J2024-0060
PSP2025-0004
Revision #2
 Received 7/17/2025

Site Plan Review
 Reviewed for compliance with City Ordinance, Building and Fire Codes. Conditions and mark-ups noted throughout plan set must be addressed prior to final approval.

1950 E. Avon Rd
 Rochester Hills, MI 48307
 Parcel # 15-13-427-002

Site Plan (Overall Site Layout)

1950 E. Avon Rd
 Rochester Hills, MI 48307
 Parcel # 15-13-427-002
 Paving & Grading Plan
 (Site Plan)

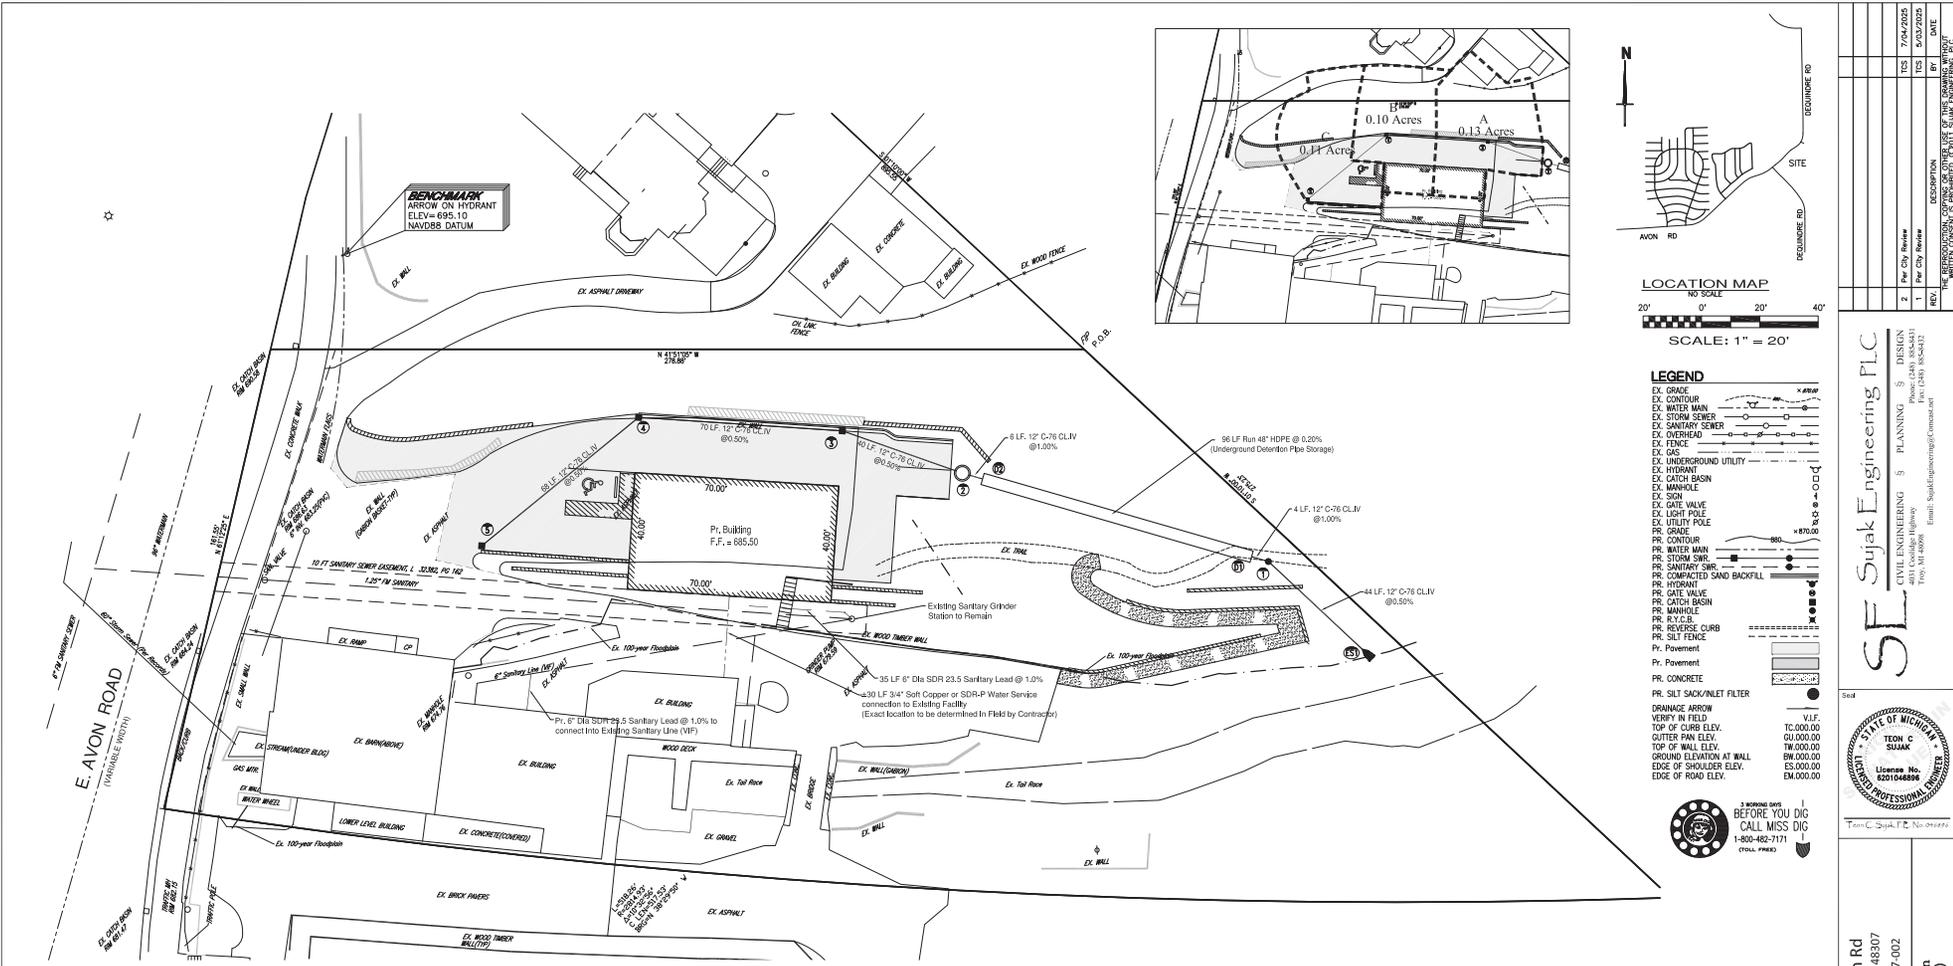
All ground mounted utilities shall be fully screened from view.

Maintenance: The owner, tenant, occupant or person responsible for any property which was the subject of an approved site plan shall maintain the property and the improvements thereon in accordance with the approved site plan or an approved amendment thereof. This responsibility shall include the duty to maintain in a condition substantially similar to that approved, including the duty to replace, if necessary, all improvements such as, but not by way of limitation, all greenbelts, planting, walls, fences, paving, trash receptacles, handicapped parking areas, etc.

The applicant will need to submit a Land Improvement Permit (LIP) application with engineer's estimate, fee and construction plans to proceed with the construction plan review process.

SIDE (SOUTHEAST) ELEVATION

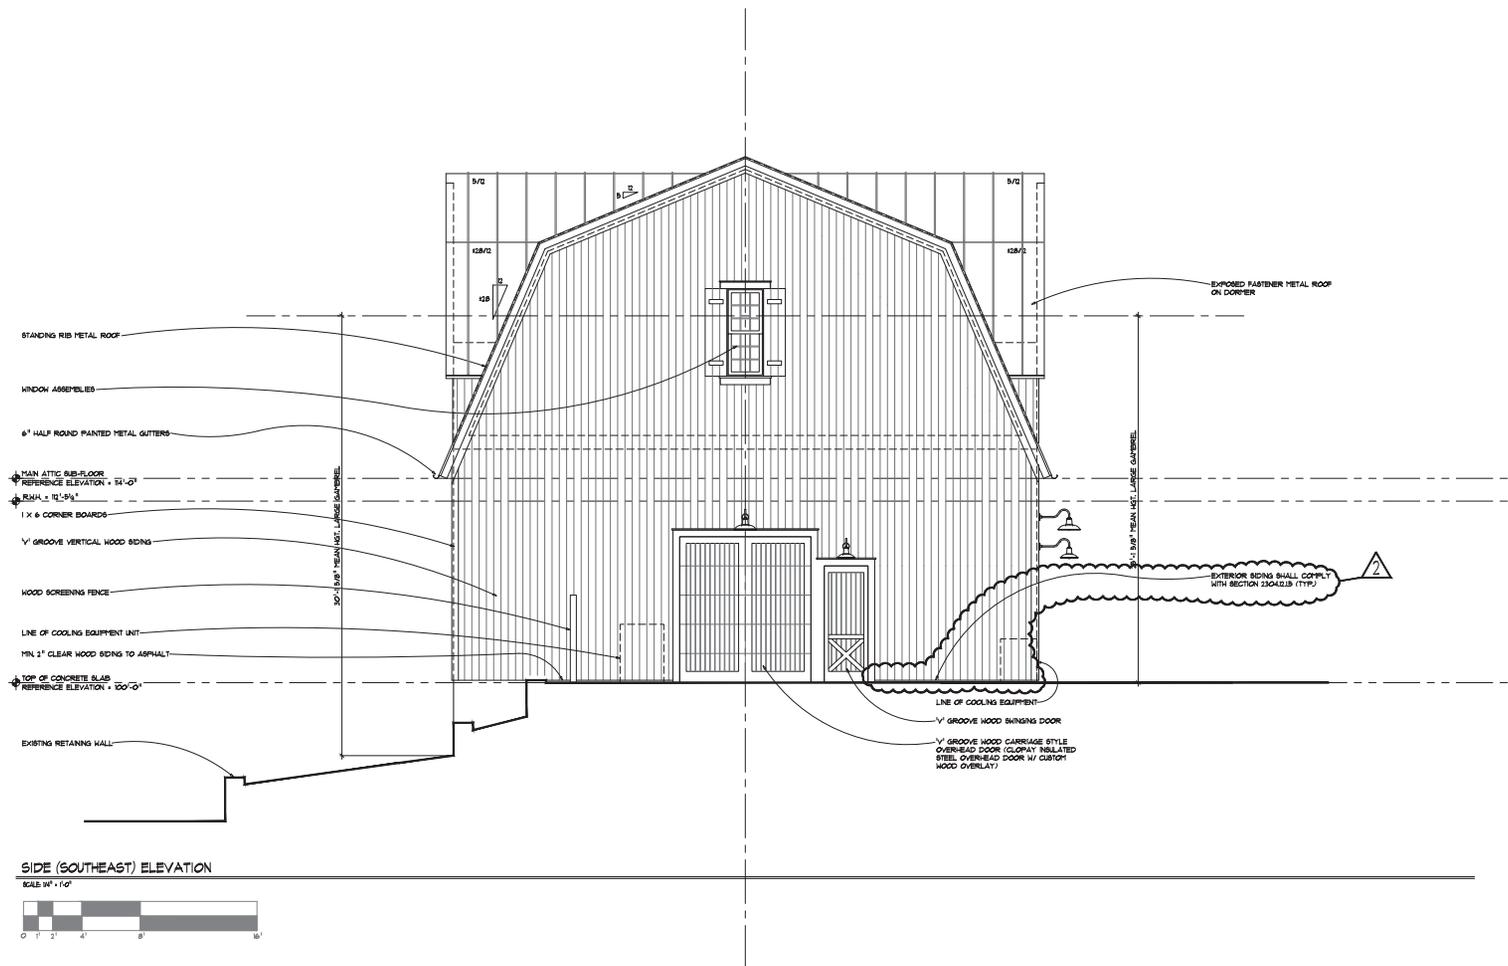
Historic District Commission approval granted on July 10, 2025. Materials were accepted as presented and being compatible with Yates Cider Mill Noncontiguous Historic District.

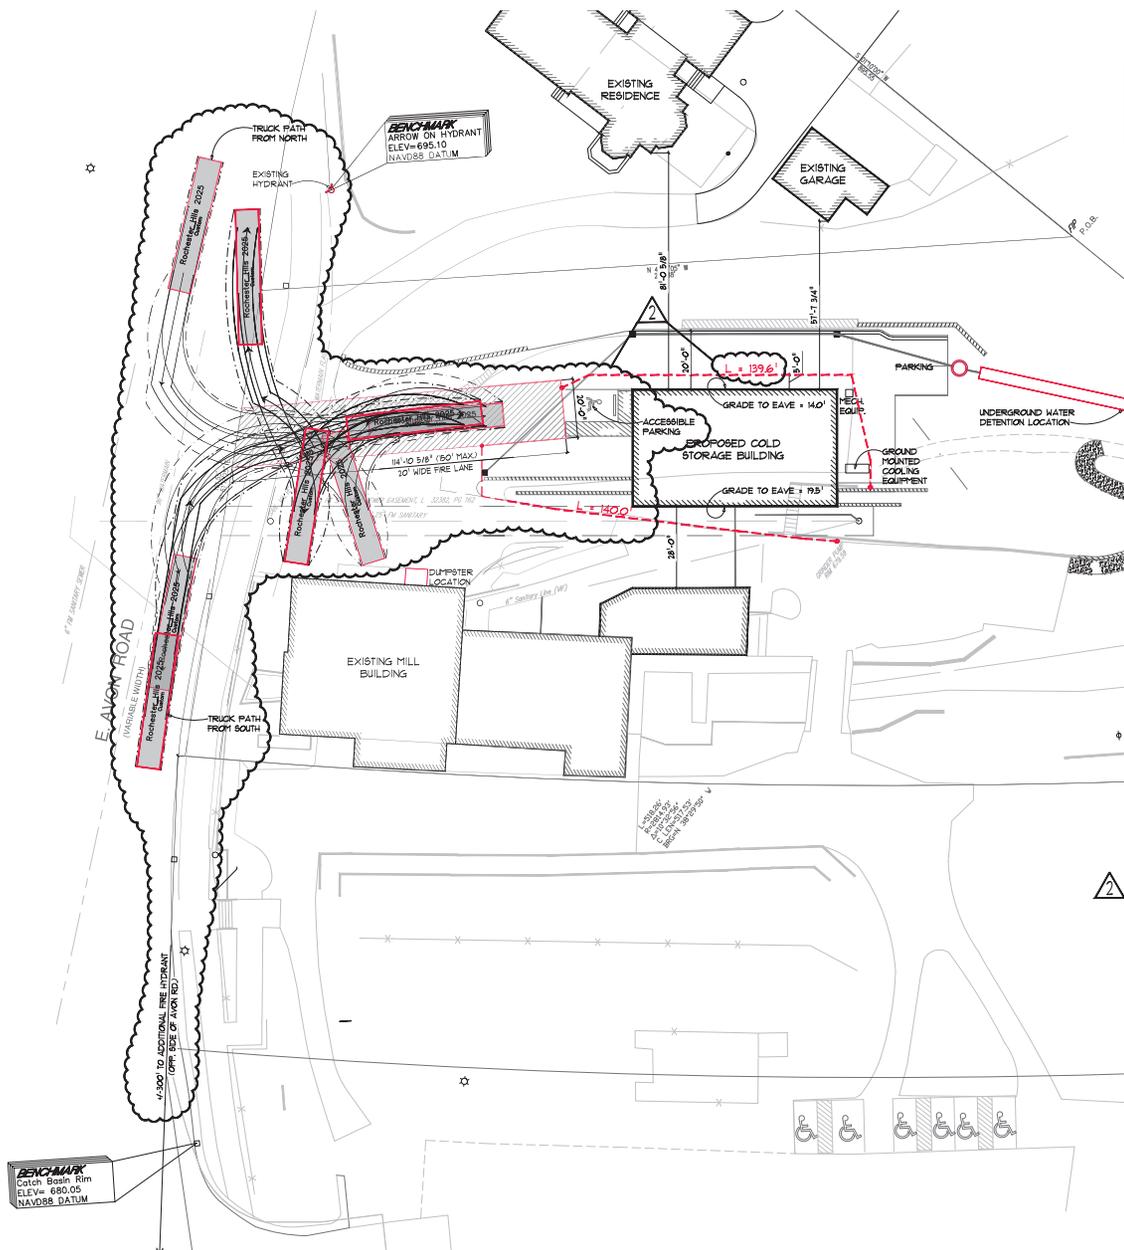
Provide cost estimate for all proposed landscaping and irrigation. This will be used to generate Landscape Bond amount plus applicable fees. Response letter notes an attached document for costs but attachment does not appear to have been submitted. Submit prior to Planning Commission date.
